dsPIC33FJ06GS001/101A/102A/202A and dsPIC33FJ09GS302 Family Silicon Errata and Data Sheet Clarification

The dsPIC33FJ06GS001/101A/102A/202A and dsPIC33FJ09GS302 family devices that you have received conform functionally to the current Device Data Sheet (DS75018C), except for the anomalies described in this document.

Data Sheet Clarifications

FIGURE 1: TIMING DIAGRAMS FOR CENTER-ALIGNED AND EDGE-ALIGNED MODES

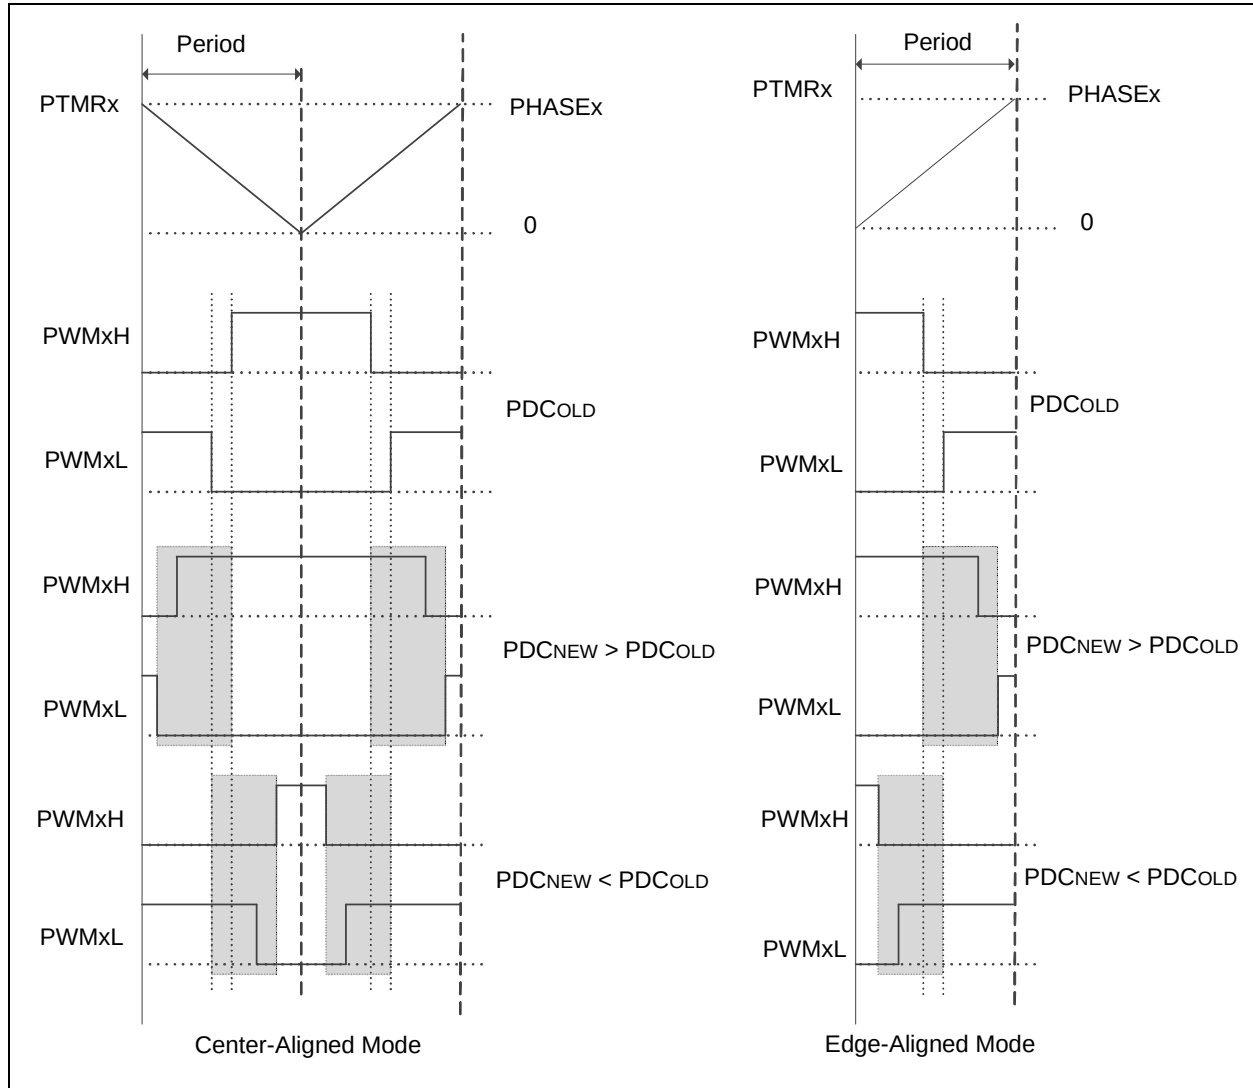
The PWMx generator may not assert dead time on the edges of transitions. This has been observed when all of the following conditions are present:

- The PWMx generator is configured to operate in Complementary mode with the independent time base or master time base;
- Immediate update is enabled; and
- The value in the PDCx register is updated in such a manner that the PWMxH and PWMxL outputs make an immediate transition.

The current duty cycle, PDCOLD, newly calculated duty cycle, PDCNEW, and the point at which the write to the Duty Cycle register occurs within the PWMx time base, will determine if the PWMxH and PWMxL outputs make an immediate transition. PWMxH and PWMxL outputs make an immediate transition if the Duty Cycle register is written with a new value, PDCNEW, at a point of time when the PWMx time base is counting a value that is in between PDCNEW and PDCOLD. Additionally, writing to the Duty Cycle register close to the instant of time where dead time is being applied may result in reduced dead time, effective on the PWMxH and PWMxL transition edges.

In [Figure 1](#) (following page), if the duty cycle write occurred in the shaded box, then PWMxH and PWMxL will make an immediate transition without dead time.

None. However, in most applications the duty cycle update timing can be controlled using the TRIGx trigger or Special Event Trigger such that the above mentioned conditions are avoided altogether.

FIGURE 2: ISSUE EXAMPLE FOR REDUNDANT OUTPUT MODE

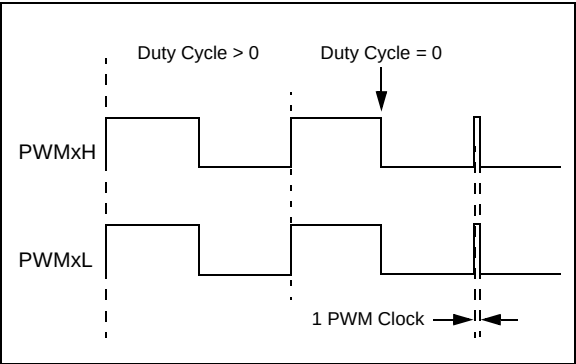
In Redundant Output mode (IOCONx<11:10> = 01) and Push-Pull Output mode (IOCONx<11:10> = 10) with the Immediate Update Enable bit (PWMCONx<0> = 0) disabled, when the Duty Cycle register is updated from a non-zero value to zero, a glitch pulse of a width equal to 1 PWM clock will appear at the next PWM period boundary, as shown in Figure 2 (for the Redundant Output mode). The Duty Cycle register refers to the PDCx register if PWMCONx<8> = 0 or the MDC register if PWMCONx<8> = 1.

If the application requires a zero duty cycle output, there are two possible work around methods:

1. Use the PWM override feature to override the PWM output to a low state instead of writing to the Duty Cycle register. In order to switch back to a non-zero duty cycle output, turn off the PWM override. The override-on and override-off events must be timed close to the PWM period boundary if the IOCONx register has been configured with IOCONx<0> = 0 (i.e., output overrides through the OVRDAT<1:0> bits occur on the next CPU clock boundary).
2. Enable the Immediate Update Enable bit (PWMCONx<0> = 1) while configuring the PWMx module (i.e., before enabling the PWMx module, PTCON<15> = 1). With the Immediate Update enabled, writes to the Duty Cycle register can have an immediate effect on the PWM output. Therefore, the duty cycle write operations must be timed close to the PWM period boundary in order to avoid distortions in the PWM output.

FIGURE 3: ISSUE EXAMPLE IN PUSH-PULL MODE

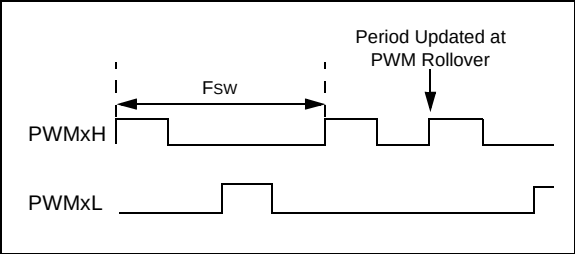
When the PWM module is configured for Push-Pull mode (IOCONx<11:10> = 10) with the Enable Immediate Period Updates bit enabled (PTCON<10> = 1), a write to the Period register that coincides with the period rollover event may cause the push-pull output logic to produce back-to-back pulses on the PWMx output pins (Figure 3).

Use either the PWMx Special Event Compare (SEVTCMP) or PWMx Primary Trigger Compare Value (TRIGx) to generate a PWM Interrupt Service Routine (ISR) near the start of the PWM cycle. This ISR will ensure that period writes do not occur near the PWM period rollover event.

FIGURE 19-2: ADC BLOCK DIAGRAM FOR THE dsPIC33FJ06GS101A DEVICE

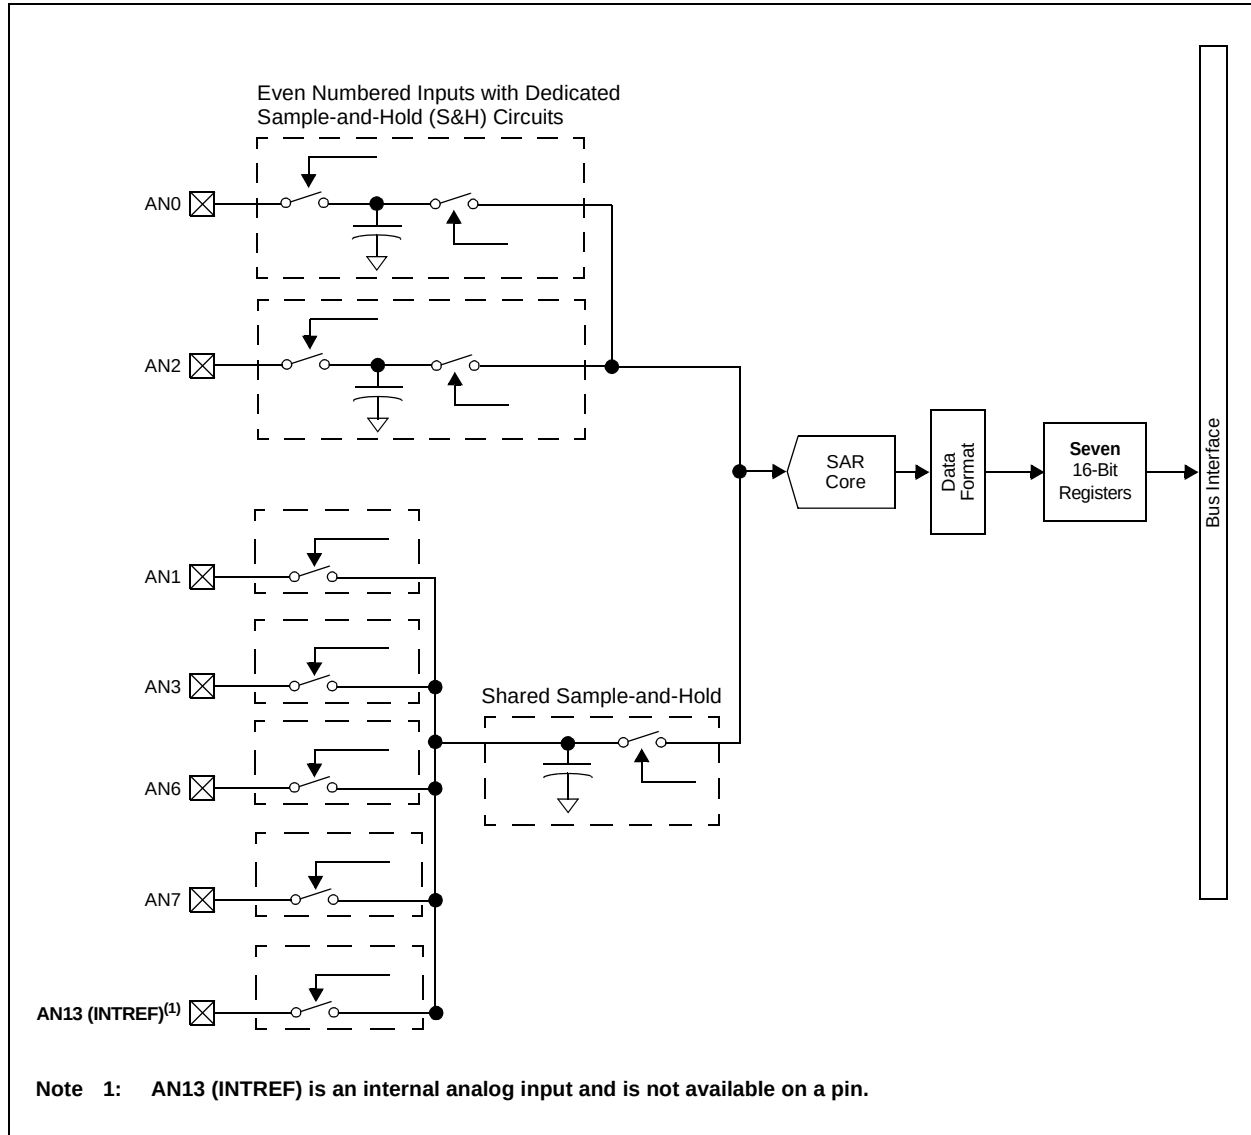
In [Figure 19-2](#) and [Figure 19-3](#), AN13 has been added and the number of output registers has been changed from eight to seven.

FIGURE 19-5: ADC BLOCK DIAGRAM FOR THE dsPIC33FJ09GS302 DEVICE

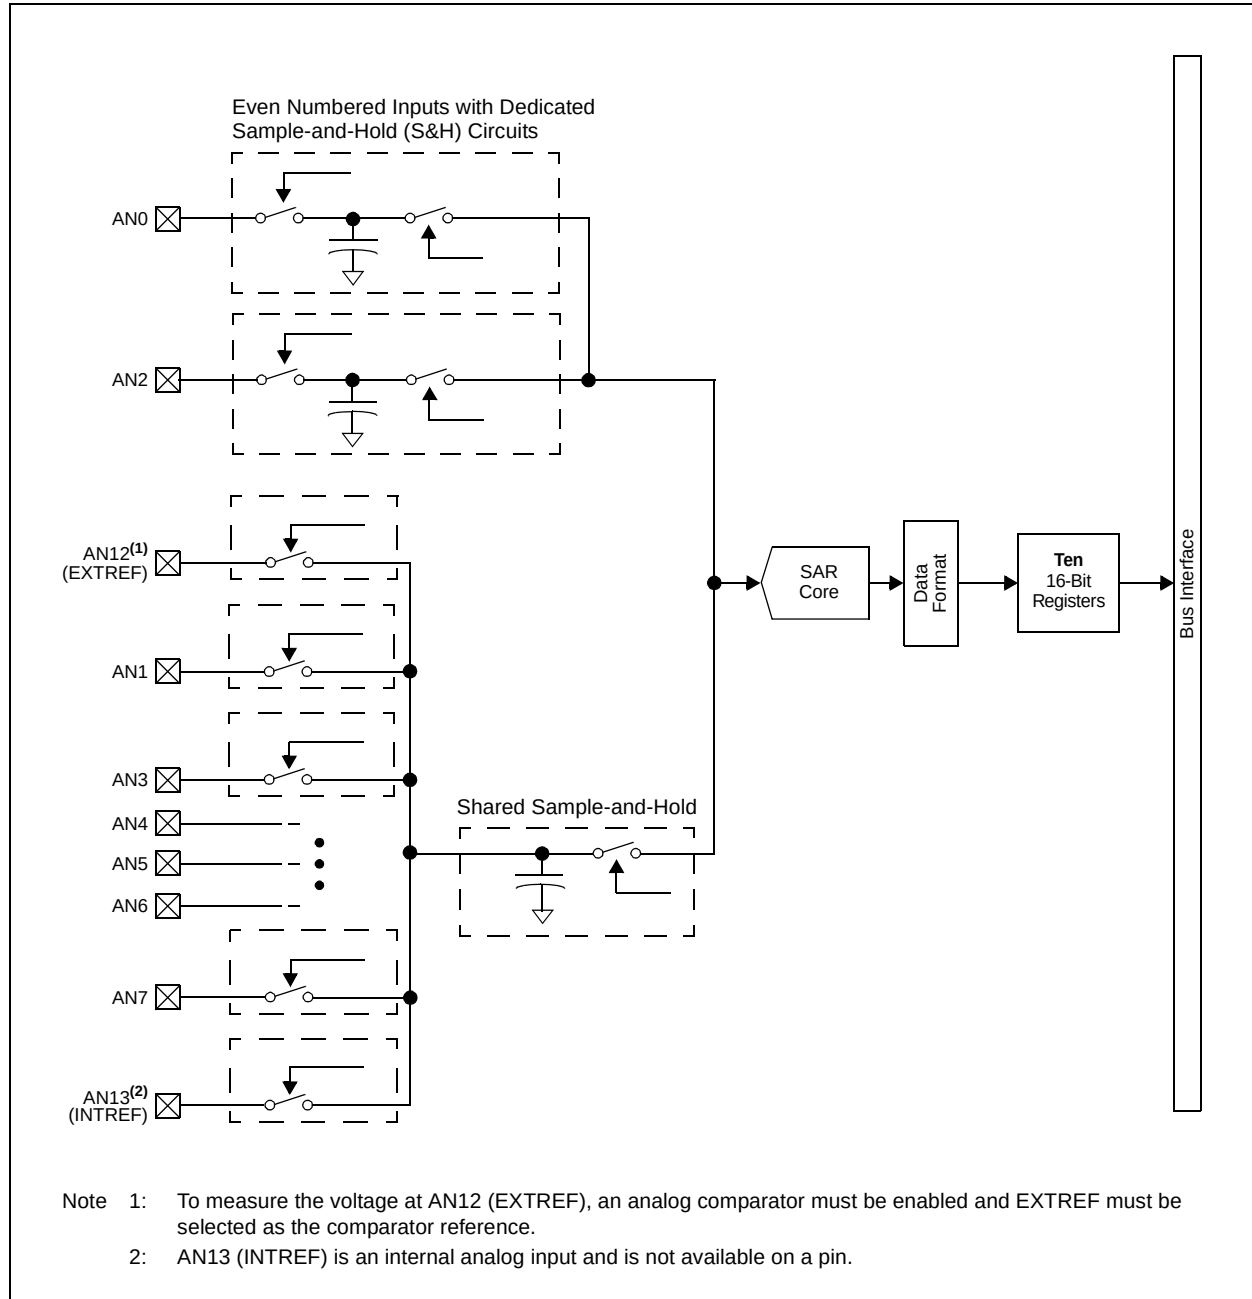
In [Figure 19-5](#), the number of output registers has been changed from eight to ten. The changes are shown in bold below:
